TOWN AND COUNTRY PLANNING ACT 1990 CONSULTATION RETURN: SCC/0045/23SE

PROPOSAL: Construction and operation of an anaerobic digestion facility, associated infrastructure and new access road, connecting pipeline and covered digestate lagoons.

LOCATION: Land to the north of Spring Grove Farm, Withersfield, Suffolk, CB9 7SW

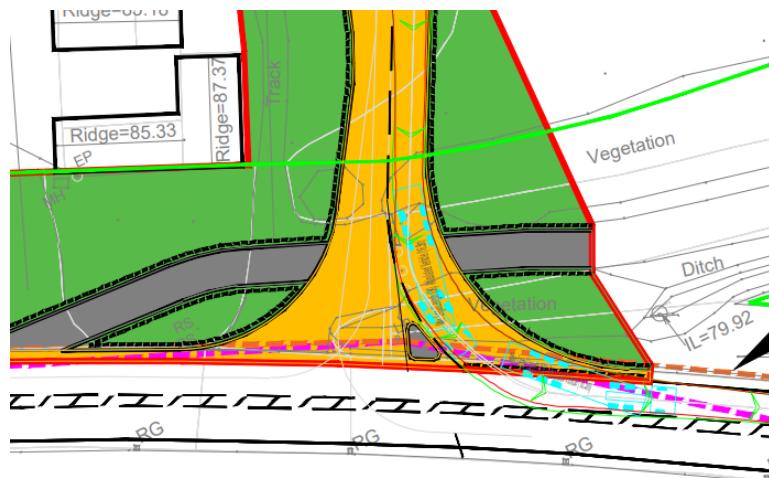
We note the left turn only departure manoeuvre and agree that the design may be the most appropriate, but it will intensify use of the roundabout. We note that a left turn arrival only is unfortunately not readily achievable at this location.

The proposed number of trips is high with exceptionally high seasonal peaks and we note that the HGV and tractor vehicles that will intensively use the access are slow moving and long meaning the turning manoeuvres require large gaps in oncoming traffic. The TS has not addressed the impact of vehicles waiting to turn right on the west bound lane. We recommend that an assessment of queue length should be provided along with consideration of the impact on highway safety. It would be appropriate for the assessment to consider if a right turn lane should be provided to reduce the impact of queuing. There would appear to be sufficient highway land for a turning lane to be provided.
